RE: Response to Information Request for material change of use involving Multiple dwellings (7 units) upon land at 112-112A Racecourse Road, Ascot 4007 (Lots 19-20 on RP33675) - A007001997

We write in relation to the development application over the abovementioned site (Council ref: A007001997) and provide the following response to Council's information request correspondence, dated 15 May 2026, under section 13.2 of the *Development Assessment Rules*.

Figure 1 – Revised ground level plan showing 2.0m separation to street tree from splay

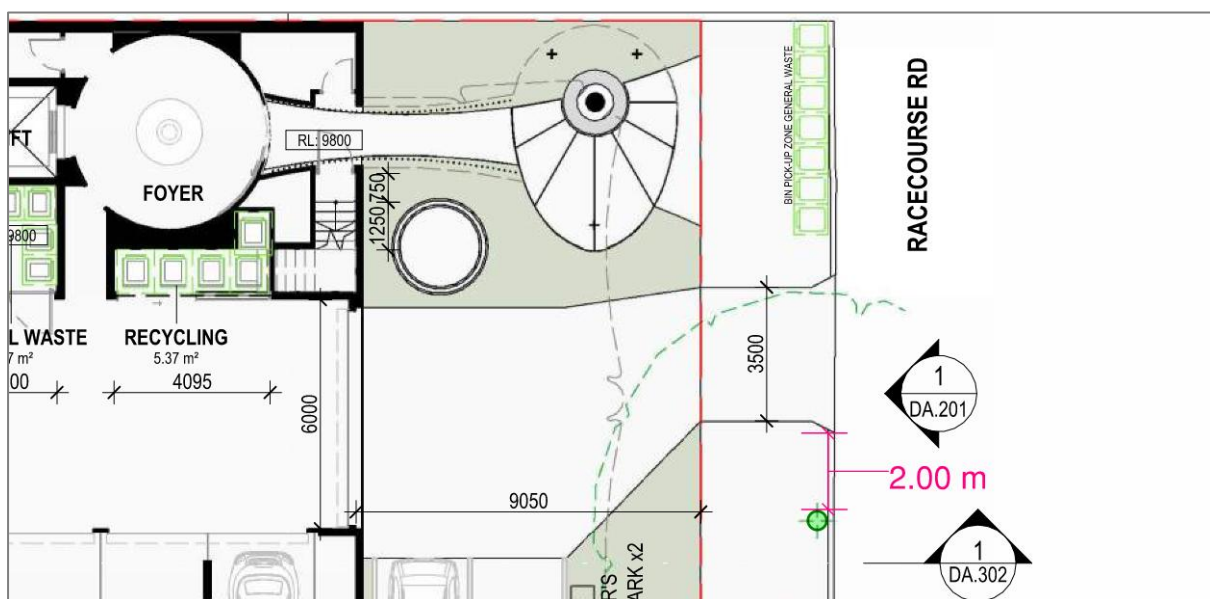
- a. *The driveway crossover is to be relocated to the north to achieve a minimum 2m of separation (including splays) to the street tree.*
 - b. *Provide a Traffic Impact Assessment (endorsed by a Registered Professional Engineer of Queensland (RPEQ)) to demonstrate the site access design standards comply with SC6.31 of the Transport, access, parking and servicing (TAPS) planning scheme policy (PSP).*

- a. The driveway crossover has been relocated further north to provide a minimum 2m separation between the crossover splays and the existing street tree. This arrangement retains the existing street tree whilst also accommodating the significant frontage constraints associated with the existing bus zone, electrical infrastructure and kerbside refuse presentation requirements.

The revised crossover location has been developed in consultation with the project traffic engineers and landscape architects to balance all competing frontage constraints whilst maintaining safe and efficient vehicle access.

Figure 2 – Kerbside allocation and vehicle access

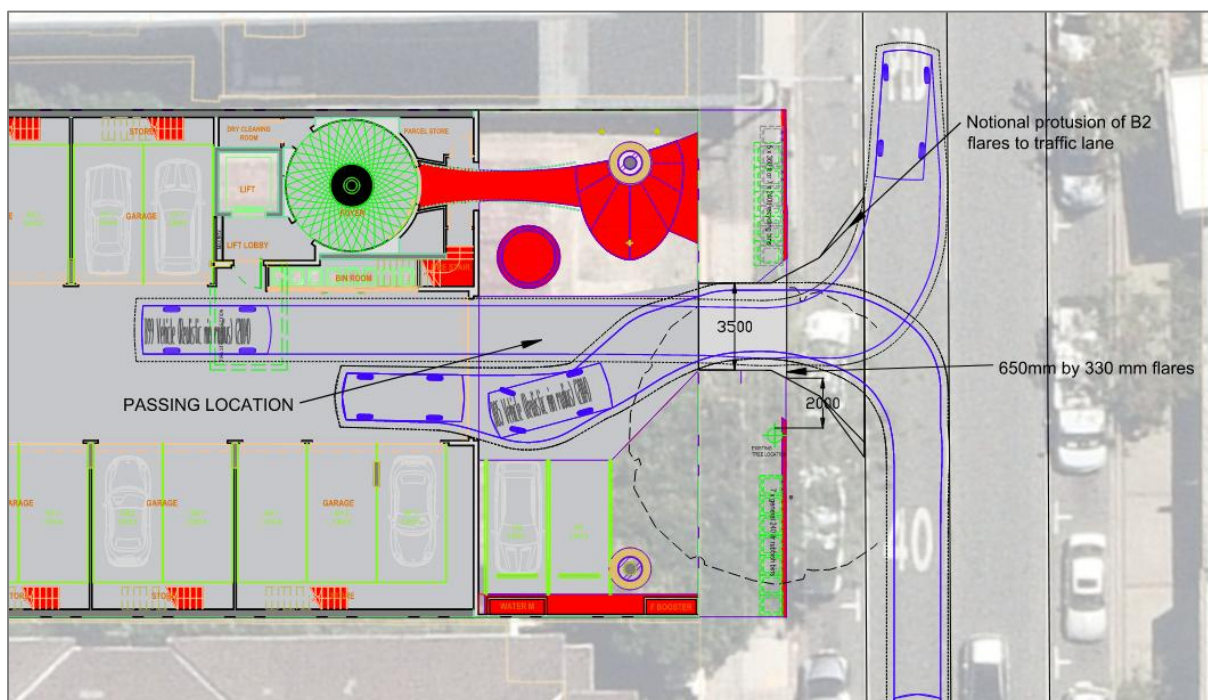
- c. *Provide detailed designs for signs and line marking related to the proposed bus zone and on-street parking on Racecourse Road, prepared and endorsed by an RPEQ.*

- d. *Provide amended plans demonstrating sufficient kerbside presentation area for seven x 240L bins for refuse and five x 360L bins for recycling (10.8m length along the kerb). Bins*

are required to be offset 2m from the trunk of the street tree, setback a minimum of 1m from the power pole and not interfere with road/street signage.

- c. The drawings identify the proposed crossover location, kerbside arrangements, bus zone interface, vehicle movements and the removal of the existing on-street parking space. The proposed arrangements have been endorsed by an RPEQ and demonstrate that the frontage can safely accommodate the proposed development whilst maintaining the functionality of the bus zone and surrounding road network.
- d. The architectural plans have been amended to provide the requested kerbside refuse presentation area.

The revised plans demonstrate sufficient verge length to accommodate seven (7) 240L general refuse bins and five (5) 360L recycling bins whilst maintaining:

- a minimum 2m offset from the existing street tree;
- a minimum 1m clearance from the existing power pole;
- separation from road signage; and
- clear pedestrian movement along the footpath.

The revised arrangement has been reviewed by Colliers International Engineering & Design and is illustrated within the accompanying kerbside allocation plan.

Figure 3 – Rooftop terrace demonstrating no areas constitute a 'storey' by definition

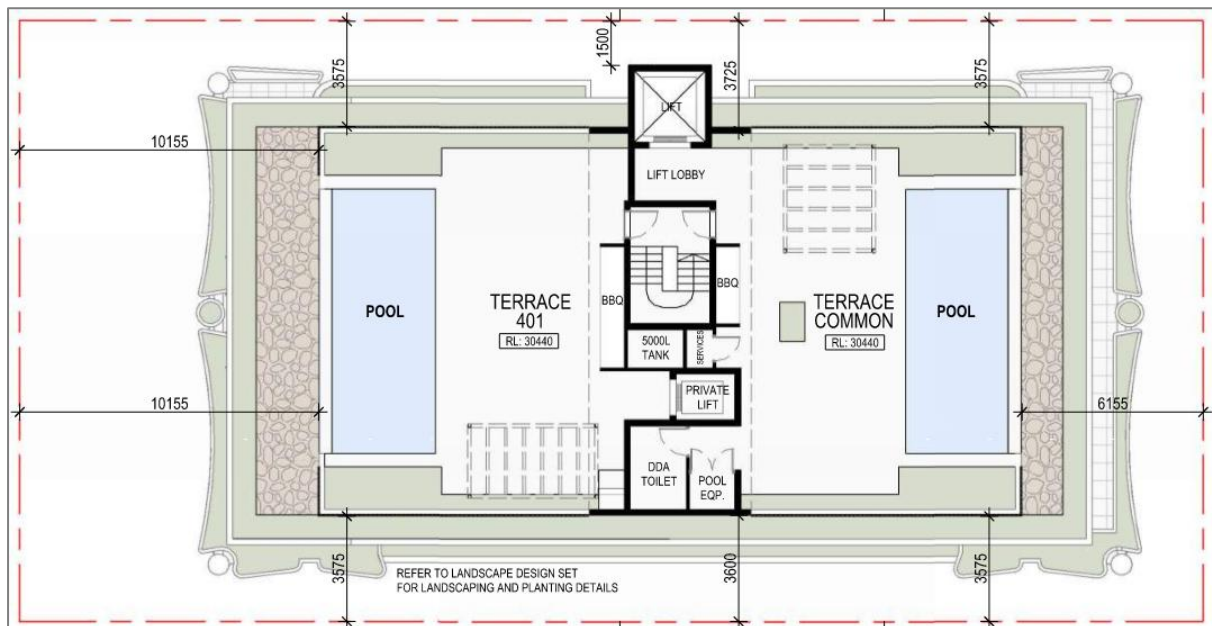
2. *Clarify whether the rooftop terrace constitutes an additional storey under the Brisbane City Plan 2014. In particular, provide an assessment against the definition of a rooftop garden and clearly identify all rooftop elements on the architectural plans.*

The architectural plans have been amended to clearly identify all rooftop elements and include a dedicated rooftop terrace plan.

As detailed within the accompanying Planning Report, the rooftop terrace does not constitute an additional storey under Schedule 1 of the Brisbane City Plan 2014.

The only enclosed roofed elements comprise the lift overrun, stairwell and associated bathroom facilities. The roof extending beyond these elements is provided solely for weatherproofing and waterproofing these building services and circulation elements and does not create an additional enclosed floor level capable of separate occupation.

The planning assessment includes a detailed review of the definition of a storey and references the Queensland Court of Appeal decision in *Robertson v Brisbane City Council & Ors* [2022] QCA 45, confirming that roofed areas associated with lift shafts, stairwells and sanitary facilities do not constitute an additional storey where they form part of the building services and circulation elements.

The rooftop area comprises open communal and private open space only and is appropriately characterised as a rooftop terrace. Accordingly, the proposal remains a five-storey multiple dwelling, with the rooftop terrace not constituting an additional storey under the planning scheme.

Figure 3 below shows the revised rooftop terrace with all roofed areas excluded from the definition of 'storey' under the planning scheme.

Figure 4 – revised bin storage area on ground level

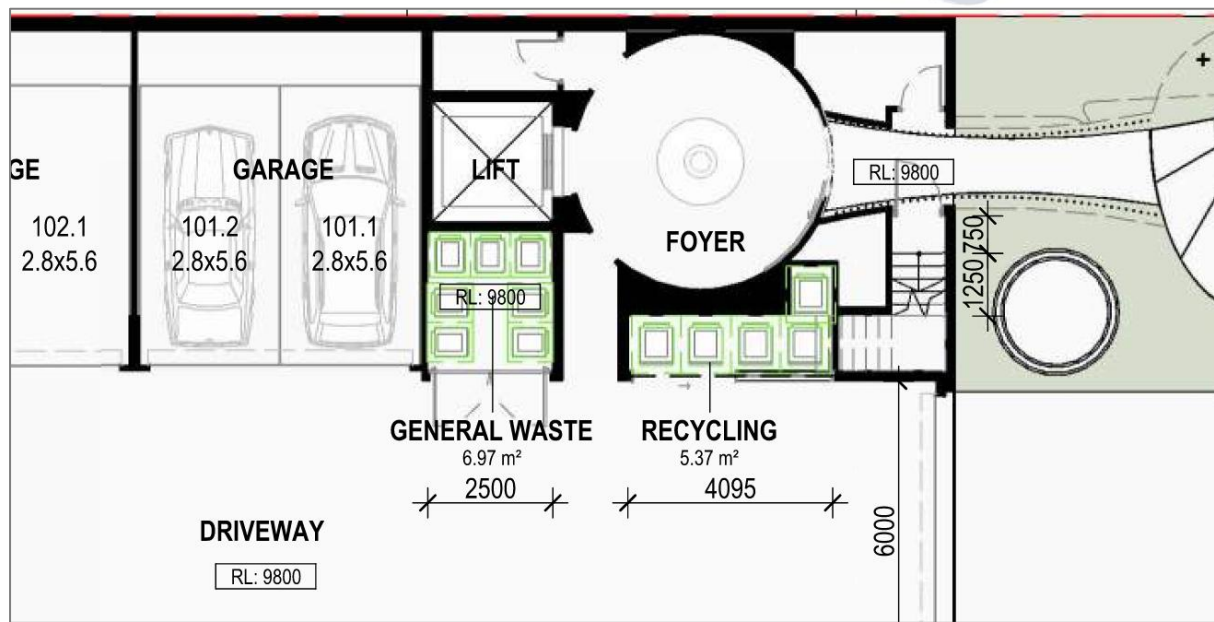
3. *Provide amended refuse storage arrangements demonstrating sufficient storage area, resident access, compliant circulation and appropriate separation between general refuse and recycling bins.*

The refuse storage area has been comprehensively redesigned.

The revised plans demonstrate:

- adequate storage for four (4) 360L general refuse bins;
- four (4) 360L recycling bins;
- compliant circulation space around all bins;
- unobstructed resident access;
- sufficient clearance beneath the stair;
- convenient transfer of bins to the kerbside collection area; and
- separation between refuse and recycling storage.

Figure 4 below shows the revised bin storage area adjacent to the entry lobby.

Figure 5 – Revised landscaping plan showing Level 1

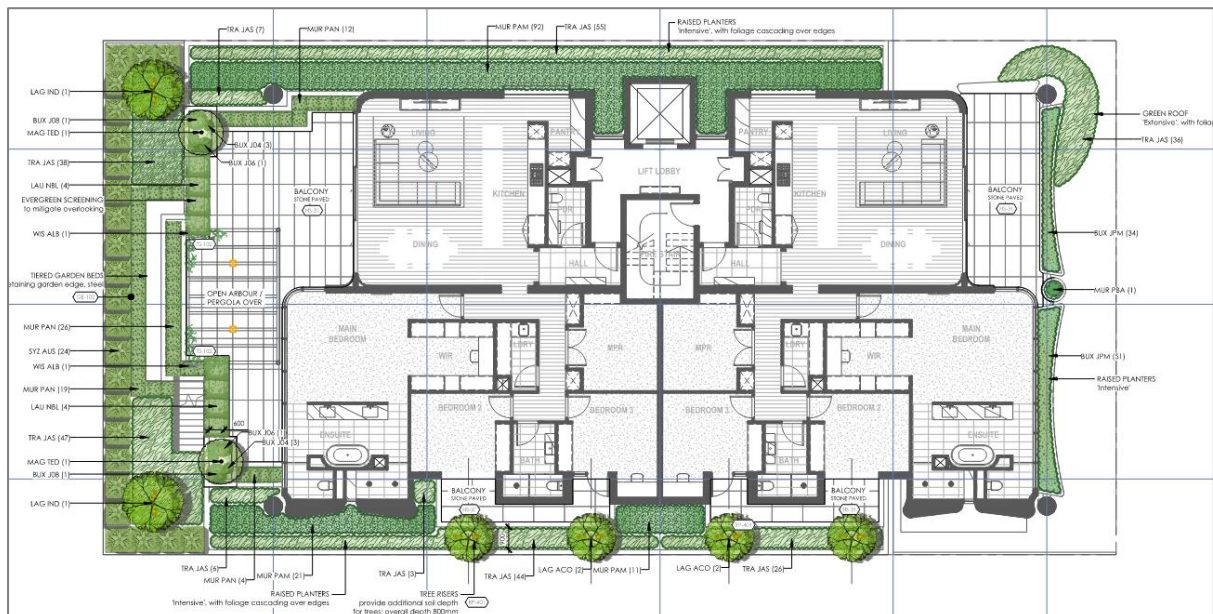
5. Provide additional deep planting and landscaping, including increased planting within the frontage and additional screening to adjoining residential properties.

Whilst the extent of deep planting has not been increased, the landscape design has been refined to further enhance the development's landscape outcome. Significant deep planting is provided along the rear boundary, creating sufficient soil volume to accommodate large subtropical shade trees that will establish a substantial landscaped buffer to the adjoining Character residential zone over time.

In addition, the proposal incorporates extensive integrated landscaping throughout the building, including generous planter boxes to balconies on every level and substantial rooftop planting. These landscaped elements soften the building's appearance, contribute to the subtropical character of Racecourse Road and provide meaningful visual greening that offsets the reduced opportunity for conventional deep planting within a centre-zoned site.

The landscape design has also been amended to increase the planting along the rear of Apartment 102, providing enhanced privacy screening between residents and the adjoining dwelling to the west.
